ASSAM GOVERNMENT - IITG HEALTHCARE FOUNDATION

Pre-Bid Meeting Summary

Tender No: AGIHF/Executing Agency/2024-25/02 date 03.01.2025

Brief Description of Procurement: Selection of Executing Agency for Construction of a Centre of Excellence in Healthcare R & D Facility – Includes Super-Specialty Hospital, PG Medical & Allied Education and Ancillary Facilities at IIT Guwahati Campus of Assam Government – IIT Guwahati Healthcare Foundation (AGIHF) On EPC Mode- III

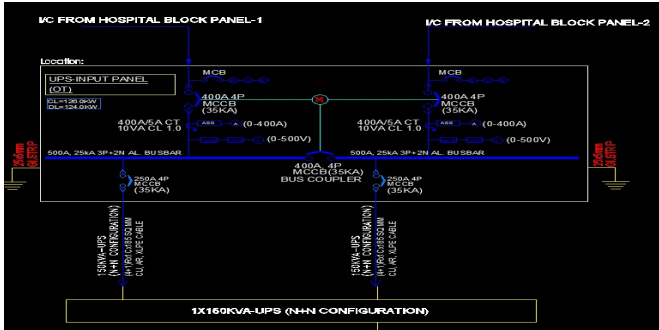
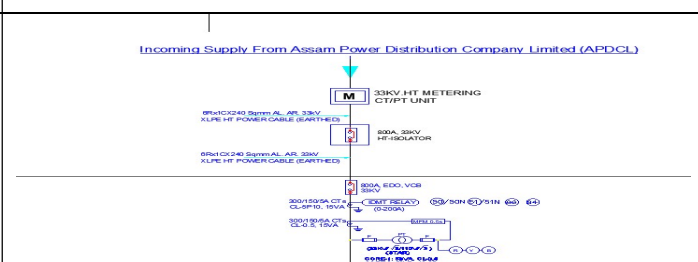
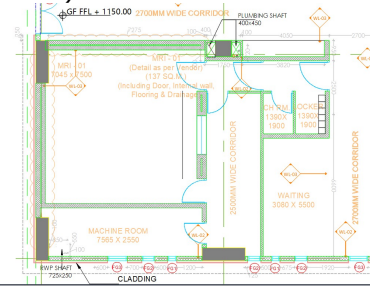
It was also noted that there is a difference in UPS SLD-s provided in Drawing folder for Hospital & Drawing folder for Master Plan & External Development.

In 1 drawing, both the Incomers of OT UPS Outgoing Panel are fed from two outgoing from 150 KVA UPS ; and in another drawing 1 no. of Incomer of OT UPS Outgoing Panel was fed from 150 KVA UPS and another Incomer from 300 KVA UPS.

Kindly clarify the difference.

We noted that as per Schedule of Items , 2 Nos of 150 KVA Modular UPS have been considered for OT with 6X25 KW Modules in each to provide N+N redundancy.

But as per SLD only 1 No. of 150 KVA

Drawing is attached in corrigendum dt.-31-01-2025. Refer the revised SLD. (DRG TITLE : MAIN SINGLE LINE DIAGRAM (UPS) DRG NO : AAHII /

6.	Drg. No. 101.2A_T- 1&2_FF&E_GROUND		As per the ground floor plan (Reference drawing: 101.2A_T-	Already uploaded on 15.01.2025.Refer dwg

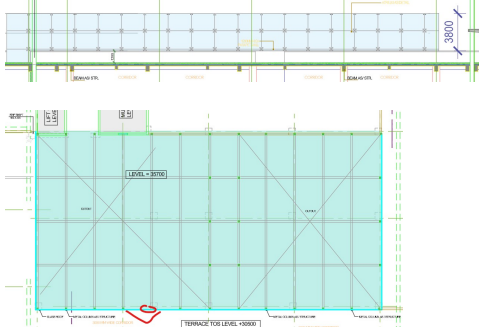
FLR, 105.1_SK SEC-E1A		1&2_FF&E_GROUND FLR), the type-4 Aluminium louvers with wooden finish size is mentioned as 100mm X 150mm, but in the Skin Section drawing (Reference Drawing: 105.1_SK SEC-E1A), under Detail 'J', it is mentioned as 50 mm X 150 mm. Kindly provide clarity.	no-AAHII / HOSP-WD/203.9
